**FINAL**  
**ENVIRONMENTAL IMPACT REPORT**  
**OTAY RIO BUSINESS PARK**  
**CHULA VISTA**

**June 24, 1987**

## COMMENTS AND RESPONSES

Figure 2-2

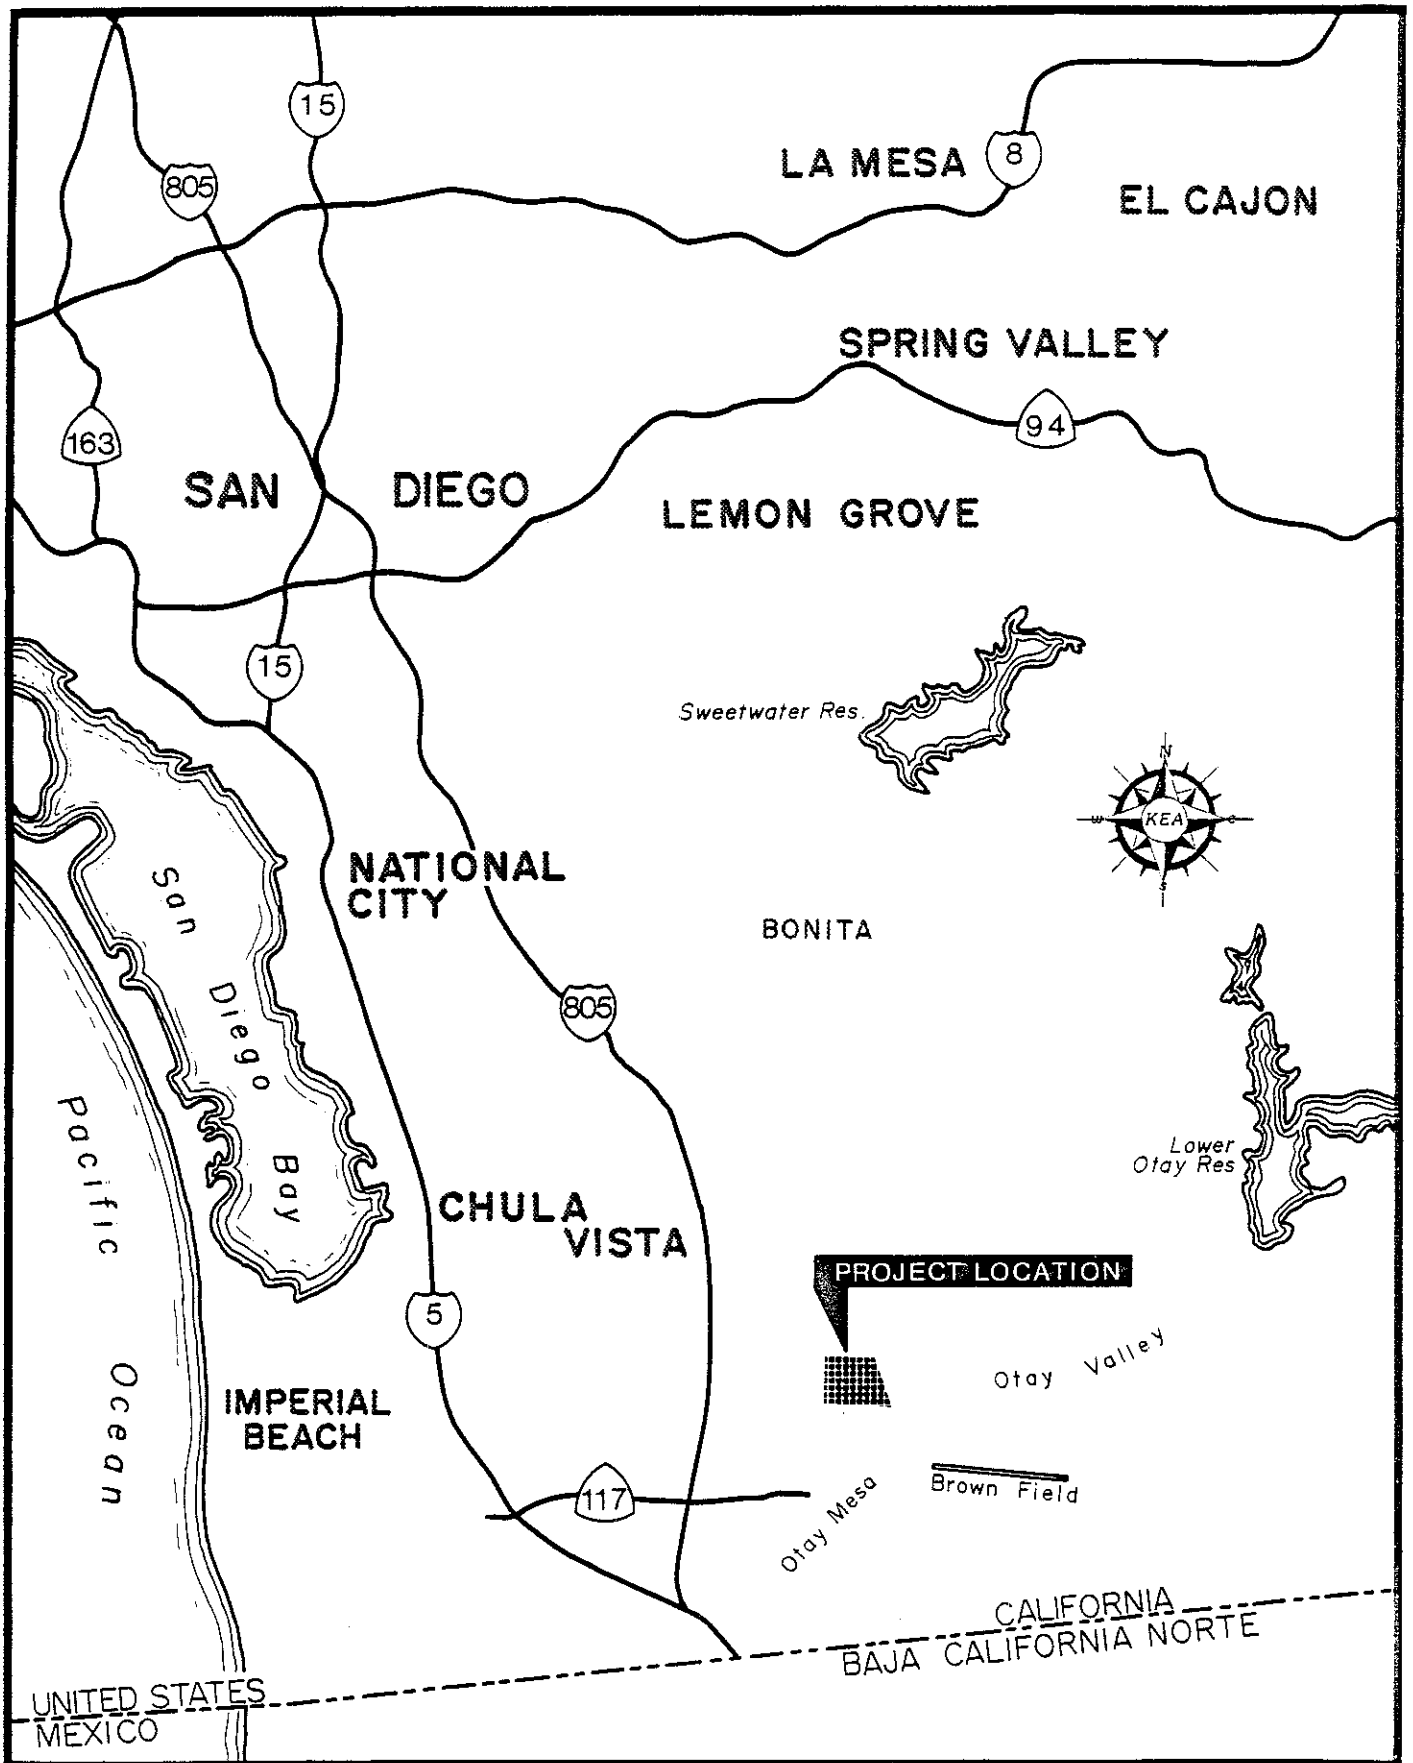
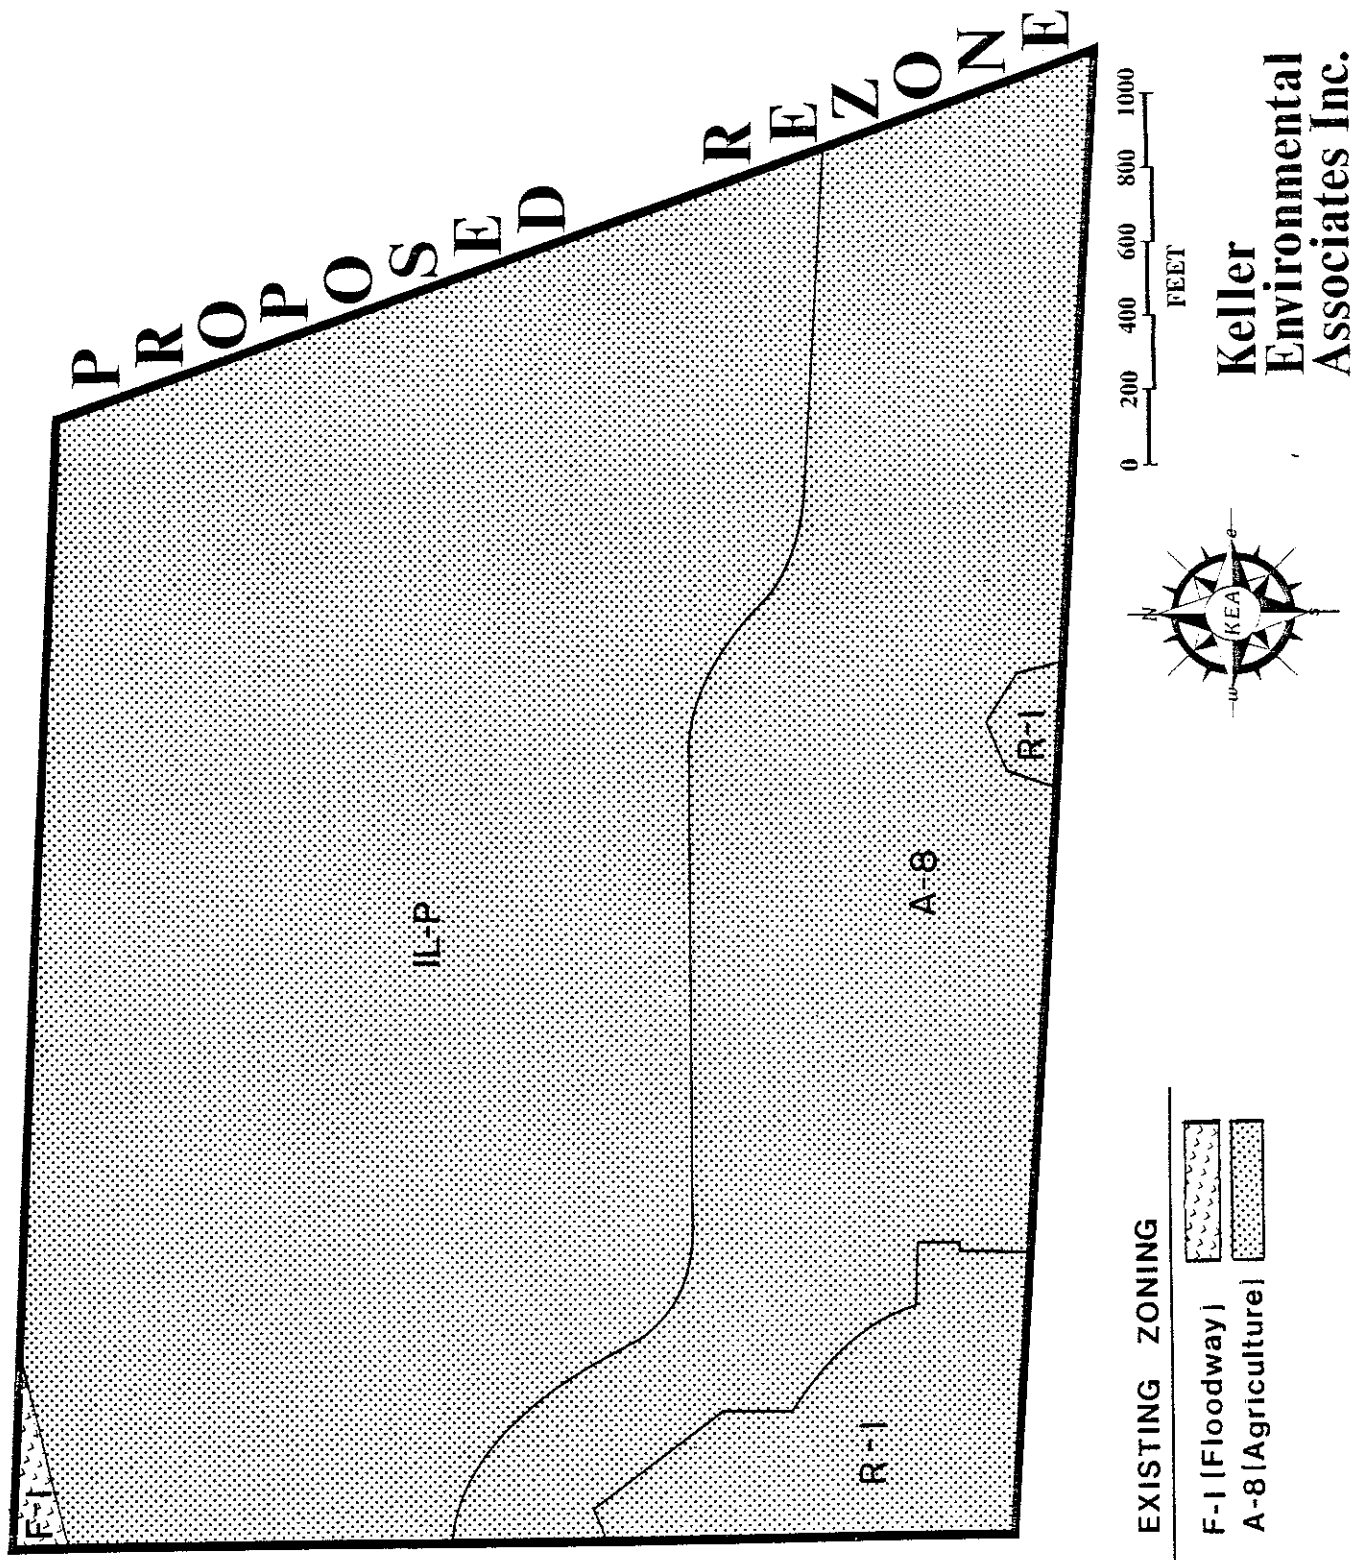
- 2F It would be helpful to have a figure of existing General Plan designations and zoning as well as proposed designations and zoning somewhere in the text to facilitate a comparison.

- 2E. The text has been expanded on page 44 to clarify the responsibility and the ensurance of these mitigation measures.
- 2F. Figures 2-2 and 2-3 following page 3 have been modified to include the existing zones and General Plan.

Figure 2-4

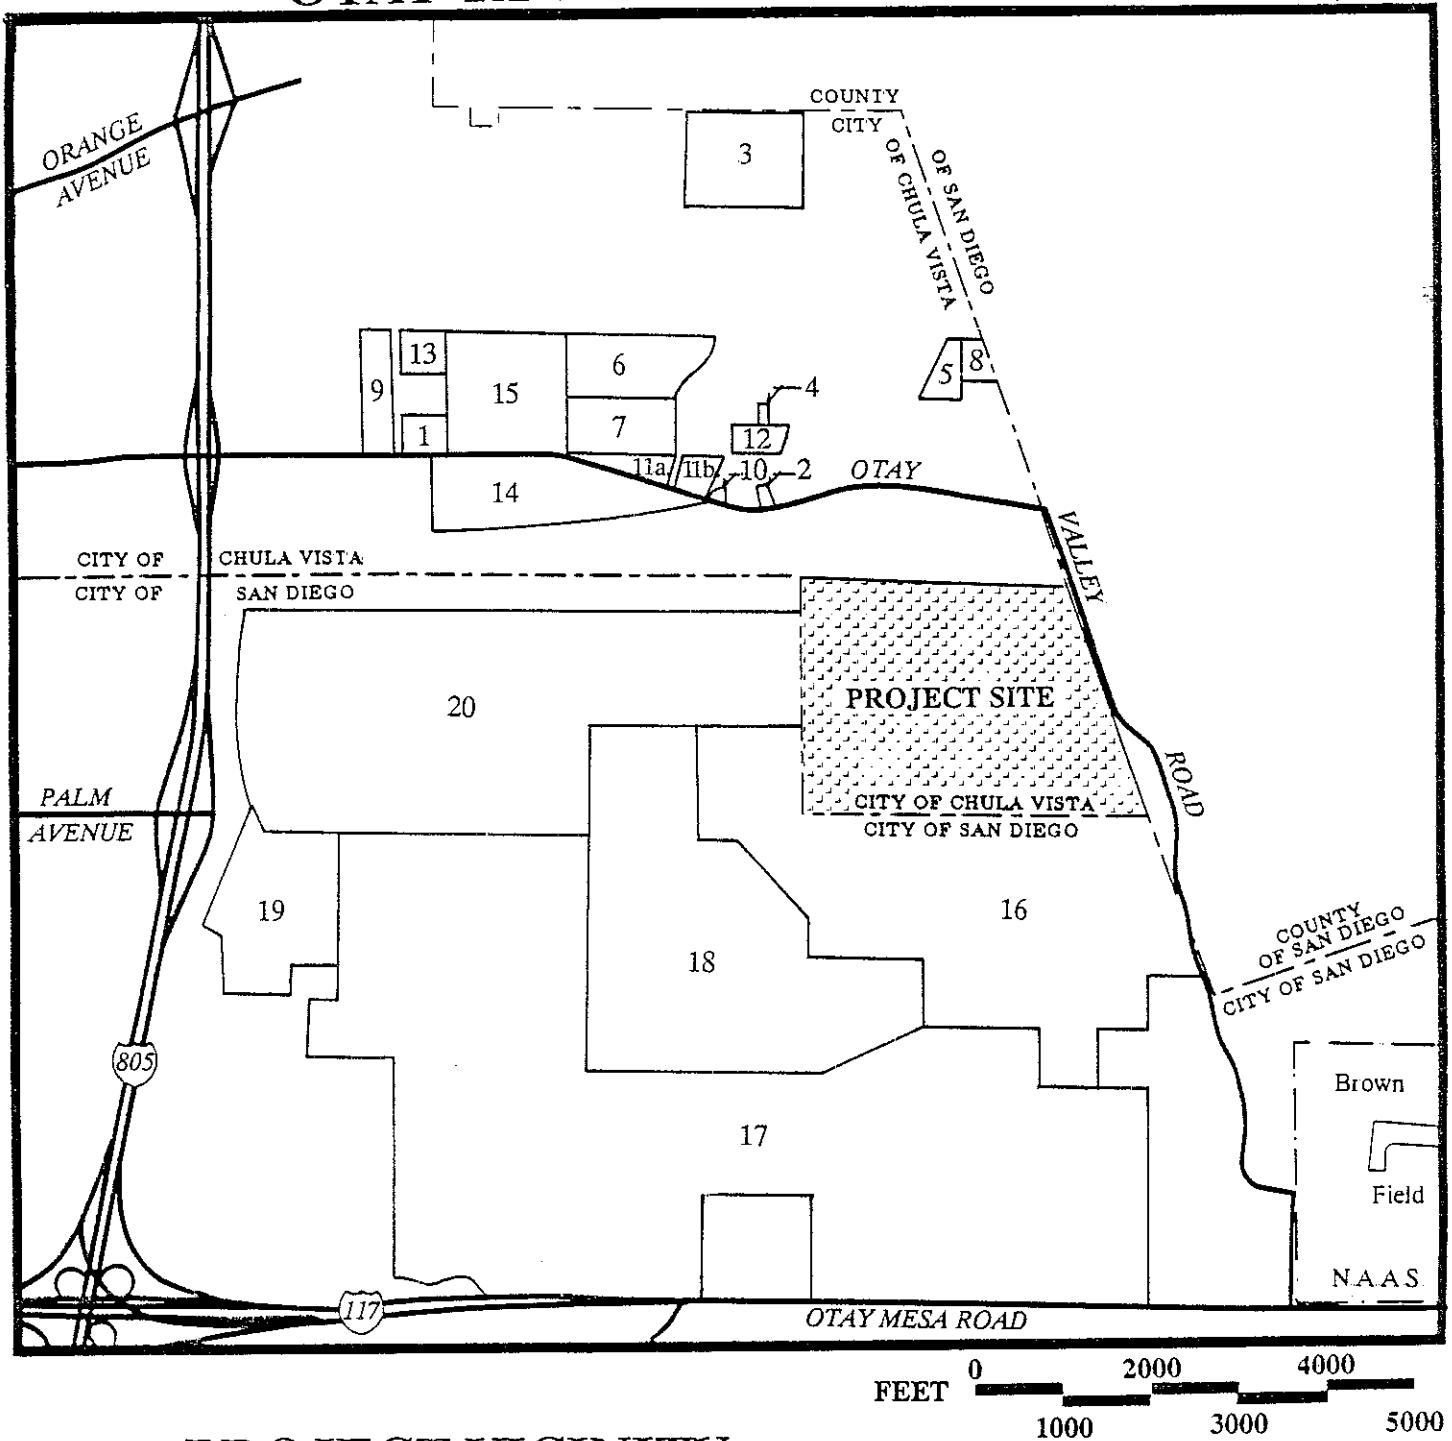
- 2G Page 70 - The Community Plans for South San Diego and the San Diego Progress Guide and General Plan identify the Otay River Valley and the southern slopes of the Otay Valley as a regional open space resource. The proposed project conflicts with these designations and thus represents an adverse environmental effect. The impact discussion should address the significance of converting designated Parks and Public Open Space to urban use. Quantification of the acreage of existing and proposed land use designations should be provided.

The existing land uses are described and acreage quantified where appropriate in paragraph 2, page 68. The acreage of proposed land uses is quantified on Figure 2-4, Tentative Map, following page 6. The Tentative Map originally did not include quantification of acreage for the residential units; that is now also included on this Figure.
